marantz

model number 18	bulletin number 69-01/18-1	date
for serial numbers	to	
subject REPLACEMENT OF DIODES IN 12 VOLT SUPPLY

marantz

model number 18	bulletin number M-18-8
for serial numbers ALL	
subject LIGHT CELL REPLACEMENT	
engineering approval <i>[Signature]</i>	date 11-25-75

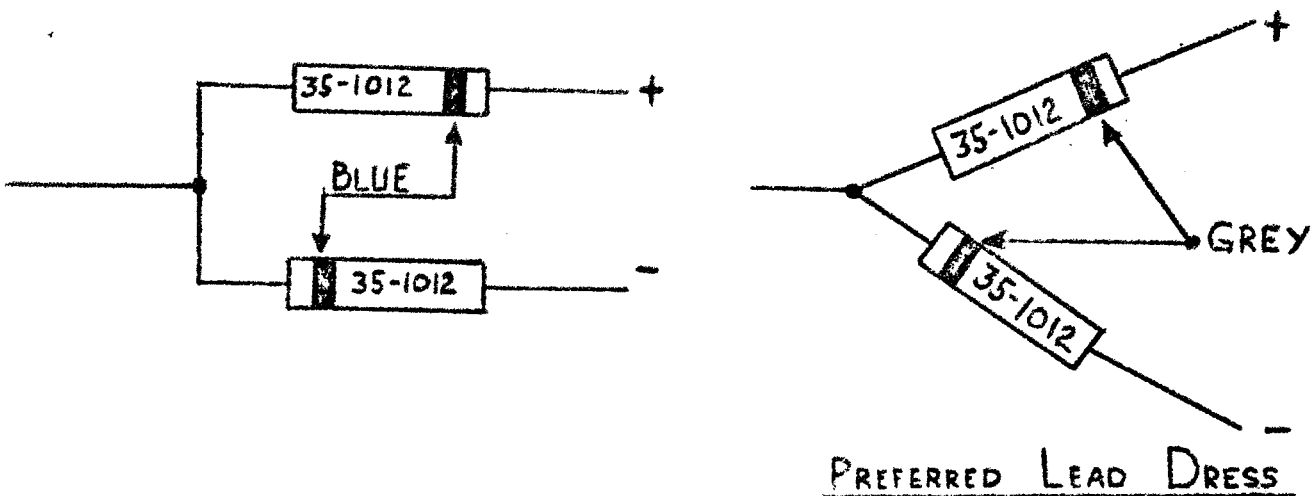
For improved reliability and performance the two Zener Diodes (CR-10 & CR-11) are being replaced by a new type. These diodes are located behind the power transformer on the top main chassis. They provide regulation for the FM sections, scope display and tone amplifier. Their failure will result in a loss of FM operation, scope display or if the fault is in the plus side of the 12V supply (CR-10) it will cause a loss of output on both channels.

The older type, to be replaced, is identified by a blue band. Its leads will be dressed at right angles. the NEW TYPE is identified by a GREY band. This is illustrated below with a drawing showing the old and the preferred new installation.

The part number for the diodes remains the same: 35-1012

FIGURE I:
MR9-054d

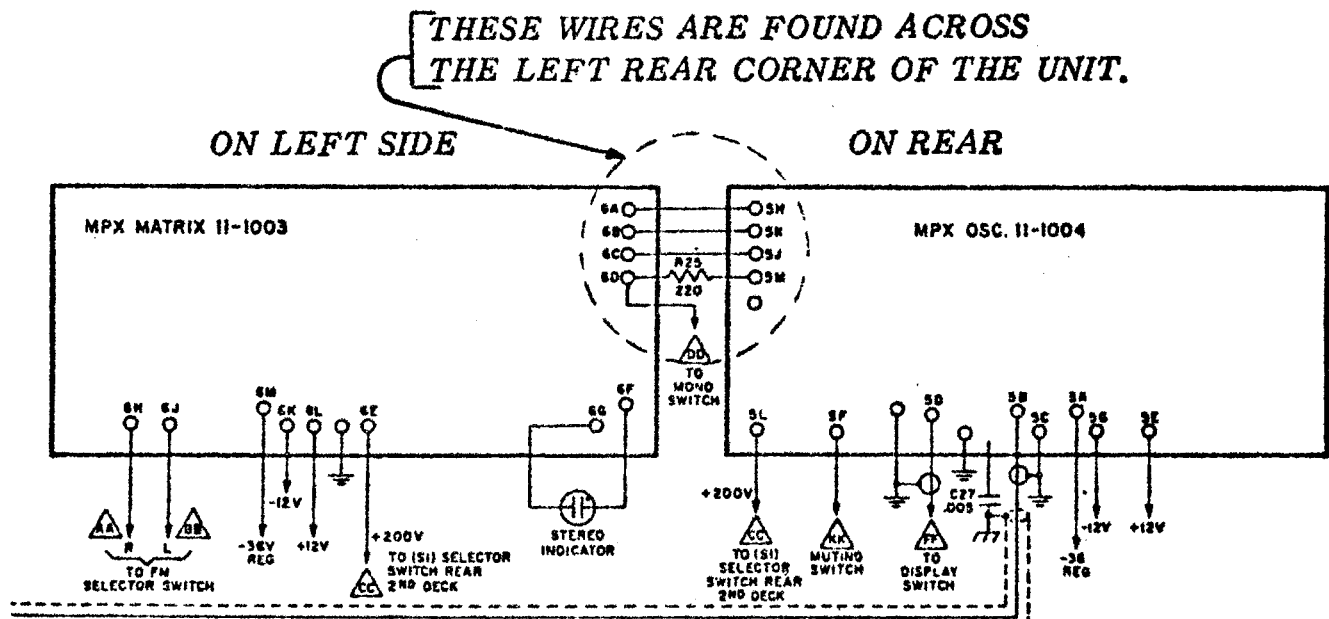
The following circuit modification is designed to correct the intermittent stereo operation in the FM mode which results from improper operation of the STEREO PHOTOSWITCH, LDR602.

1. REMOVE the three wires between the terminals of the MPX MATRIX board and the MPX OSCILLATOR board (See FIG.1). Also remove one side of resistor R-25.
2. REMOVE the two screws which secure the MPX Matrix board to the main chassis. Carefully pull the board away to expose the foil side.
3. INSTALL two insulated wire JUMPERS across both sides of the STEREO PHOTOSWITCH, LDR602 as shown in FIG.2. This effectively bypasses its operation.
4. REPLACE the matrix board on the chassis and re-solder the wires and resistor removed in step one above.

NOTE: IF THE PREVIOUS WIRES WERE SOLID, REPLACE THEM WITH STRANDED WIRE FOR GREATER FLEXIBILITY.

Replacement
LIGHT CELL ASSEMBLY, LDR501
P/N 331-1005-000

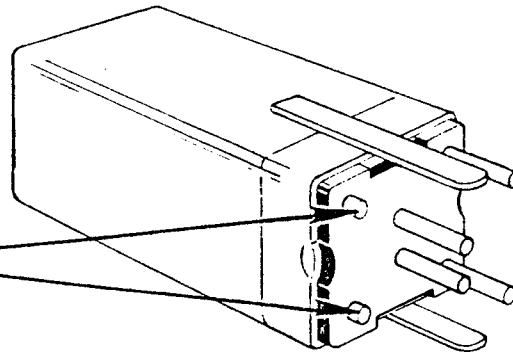
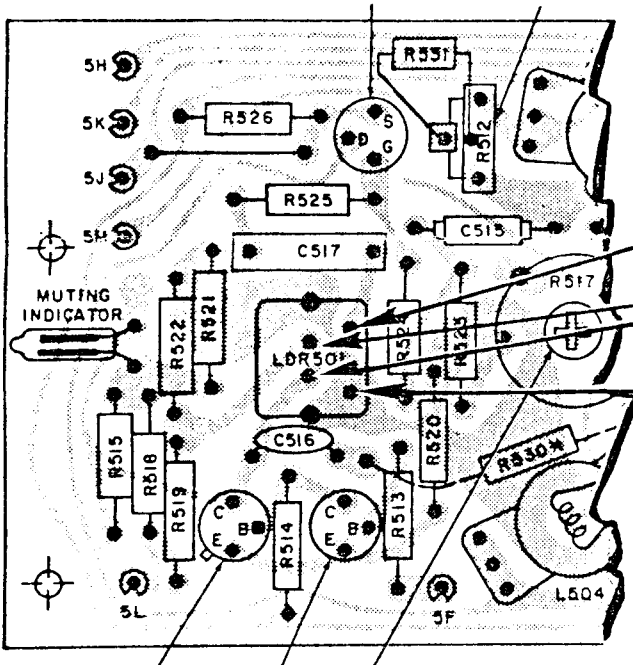
The original LIGHT CELL ASSEMBLY, Ref. Desig. LDR501, Part Number 11-1010 is no longer available and has been replaced by Part Number 331-1005-000.

Prior to installation it is necessary to modify the replacement Light Cell Assembly and the Model 18 MPX Oscillator Board as described below;

Cut (2) Leads

Enlarge PCB Holes
[to accommodate larger
lead diameter of replace-
ment LDR501]
